DEVIATION REQUEST FORM

Deviation Reference Number	DEV_530		
Date of decision	02/11/2023		
Precedent (YES/NO)	No		
Precedent details	NA		
Date of submission			
	Dd/mm/yyyy Project ID – N/A		
Project/PoA/VPA	⊠ PoA	ID - GS12375	
	□ VPA	ID – GS VPA not created yet	
Project/PoA/VPA title	Enhanced fuel combustion and engine efficiency project, bio-organic fuel treatment		
Date of listing	N/A		
GS Standard version applicable	Gold Standard Methodology "Retrofit Energy Efficiency Measures in Shipping v2.0"		
Date of transition to GS4GG (if applicable)	N/A		
Date of transition to Gold Standard from another standard (e.g. CDM) (if applicable)	N/A		
Date of design certification/inclusion (if applicable)	Not certified yet		
Location of project/PoA/VPA	Host country(ies): There is no host country. The POA and VPA(s) involve ships mostly sailing in international waters. Shipping emissions and emissions reductions are not included in the GHG inventories of any country.

Scale of the project/PoA/VPA	☐ Microscale		
	☐ Small scal		
	_	e (to be confirmed)	
Gold Standard Impact Registry link of the project/PoA/VPA		not filed yet	
Status of the project/PoA/VPA	☑ New☐ Listed☐ Certified d☐ Certified p		
T

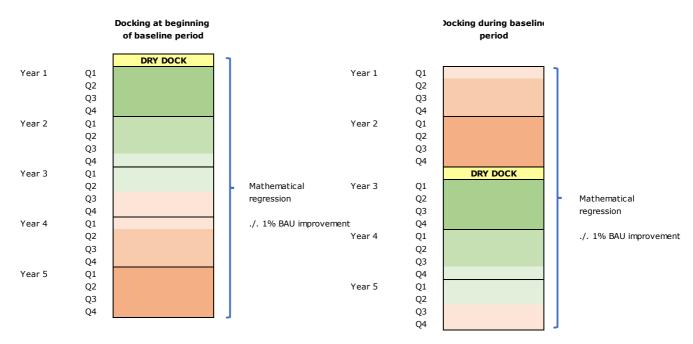
The methodology "Retrofit Energy Efficiency Measures in Shipping v2.0" states under section 3.4.2 "baseline cycle":

"The starting point is the individual ship's fuel efficiency based on the previous full dry dock cycle of operation (denominated as the "baseline dry dock cycle"). The baseline docking cycle is used to apply or adjust the Basic Model which, based on regression analysis, characterizes the relationship of baseline fuel to various explanatory variables."

The above section assumes that the retrofits are applied during the periodical dry dock mandatory stoppage / survey, which should be the case for most retrofits contemplated by the methodology, however the use of additives / fuel treatments is different as its use can start anytime during the dry dock cycle, hence the traditional docking cylces are not appropriate.

However, to match the ship performance pattern it is important the baseline is representative of a full docking cycle but it doesn't necessary need to start with the docking event. As long as the duration of the docking cycle is captured within the baseline period, the individual fuel efficiency is represented in the baseline.

It is therefore proposed to deviate from the relevant methodology and determine the baseline period as the same duration as a standard dry dock cycle (i.e. 60 or 30 months following the age of the ship) but starting 60 or 30 months prior the first day of use of fuel treatment (i.e. representing the same duration as a traditional dry dock cycle) and the project period staring at the first day of fuel treatment.

The Request is not Approved.

The developer is proposing making alterations to the traditional baseline docking cycles based on the use of fuel additive and fuel treatment that refers to fuel switch scenario, which is not applicable under <u>Table 2 Applicable conditions and means of verification</u> of the methodology.

The developer shall refer to the eligible technology applicability measures listed in Table 1 para 2.2.2 for more information.

The developer can submit a new methodology draft document highlighting the fuel switch scenario and the relevant process modifications.
